**NUMBER:** 23-019-07

**THIS BULLETIN SUPERSEDES TECHNICAL SERVICE BULLETIN 23-044-06, DATED OCTOBER 10, 2006, WHICH SHOULD BE REMOVED FROM YOUR FILES. ALL REVISIONS ARE HIGHLIGHTED WITH **\*\*ASTERISKS\*\*** AND INCLUDES A CLEAN POINT AND A CHANGE TO THE SYMPTOM/CONDITION.**

Wind-Like Sound At A-Pillar Of Windshield Frame

2007 (JK) Wrangler

**Fig. 1 WINDSHIELD FRAME REINFORCEMENT BRACKET**

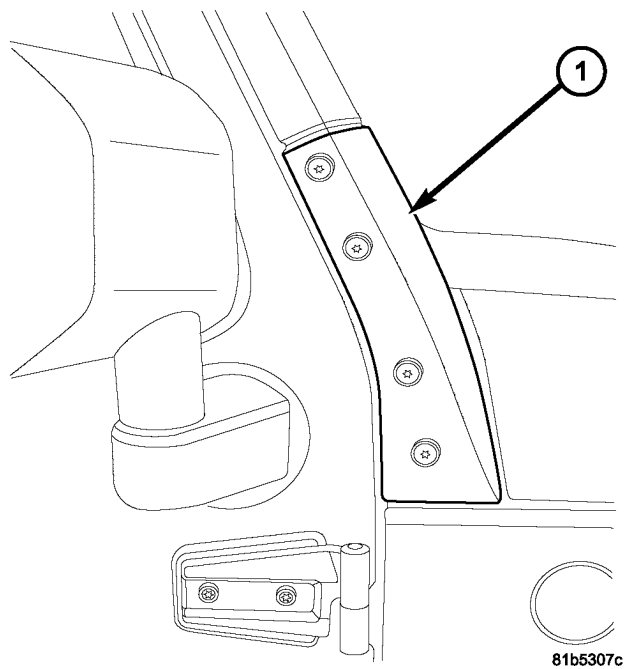
1. Remove windshield frame reinforcement bracket on A-pillar with wind-like sound (Fig. 1).

**Fig. 2 CAULK APPLICATION**

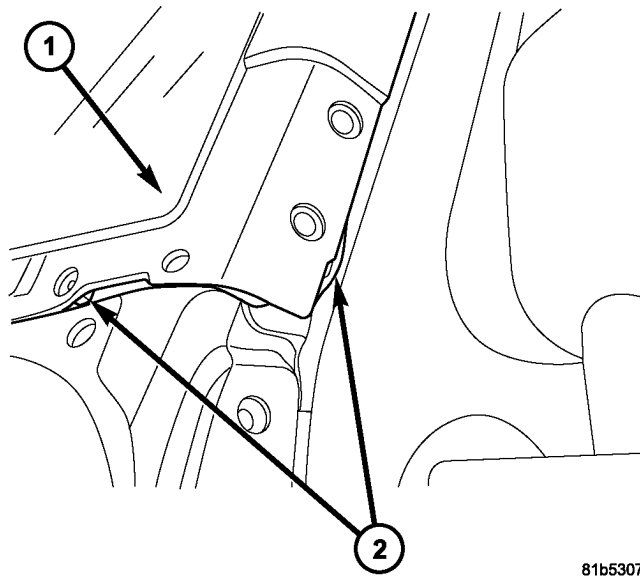
- 
- 2. Apply caulk to windshield frame weld flanges along rear of frame extending up 30 mm (1.25 in.), and forward, around frame for 65 mm (2.5 in.) (Fig. 2).
  - 3. Reinstall windshield frame reinforcement bracket.
  - 4. Tighten the windshield frame reinforcement bracket fasteners to 15-25 Nm (11-18 ft. lbs.).
  - 5. Repeat steps 1-4 for the other side A-pillar if necessary.
